Date: September 12, 2018

**Planned Unit Development (PUD)
Eligibility Review
For
City of Northville, Michigan**

Applicant:	Hunter Pasteur Northville LLC 32300 Northwestern Highway, Suite 230 Farmington Hills, MI 48334
Project Name:	The Downs Planned Unit Development (PUD)
Plan Date:	August 13, 2018
Latest Revision:	September 7, 2018
Location:	Vacant parcels on the south side of Cady St. (between S. Center and Griswold), the Northville Downs racetrack property south of Cady St. (between S. Center St. and River St.), and two areas on the west side of S. Center St.
Zoning:	CBD – Central Business District CSO – Cady Street Overlay District RTD – Racetrack District R-2 – Second Density Residential District
Action Requested:	PUD Eligibility
Required Information:	As noted within this review

Figure 2 – City of Northville Sub Area Plan Update: Racetrack

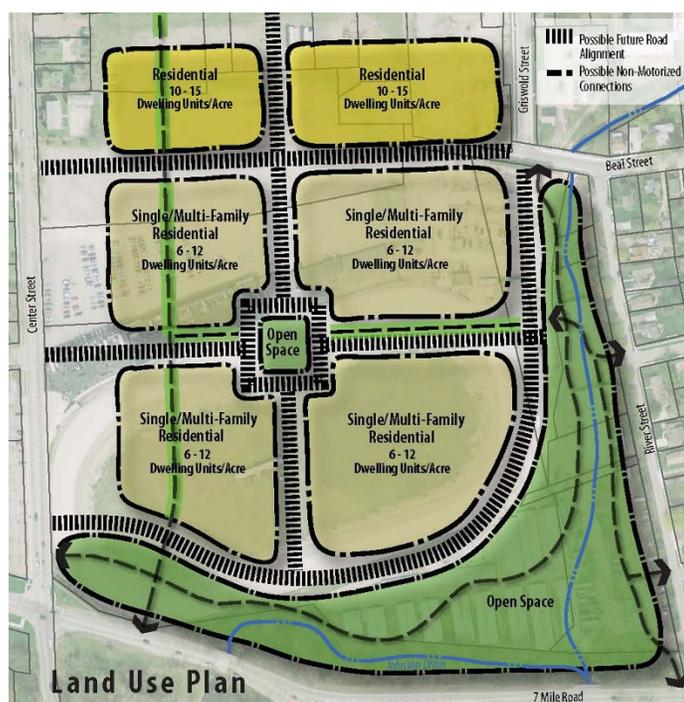
The proposed park is a positive aspect of this plan. To create a park that is consistent with the Master Plan, we would recommend that the following modifications be considered:

1. Daylight the river. This is a significant goal in the City's Master Plan. In our opinion, it would be very unlikely that the river could ever be daylighted in the future if the proposed number of home sites and townhomes abutting the park are constructed. We understand that the park was designed to allow for 140-foot wide floodplain for future daylighting of the river. However, it is unlikely that new property owners abutting this area would agree to such a proposition.

2. Eliminate the 13 home sites along River Street. The location of the pipe containing the underground river is clearly illustrated on the plans. It shows that the river is in or directly abuts four of the lots proposed along River Street. The other lots border this feature. The safety of the pipe needs to be assured if the river isn't daylighted. Eliminating these homes sites would increase the likelihood of daylighting the river in the future if not done with this development. Thirdly, eliminating these home sites would increase the usable area of the park, and allow for more space for the farmer's
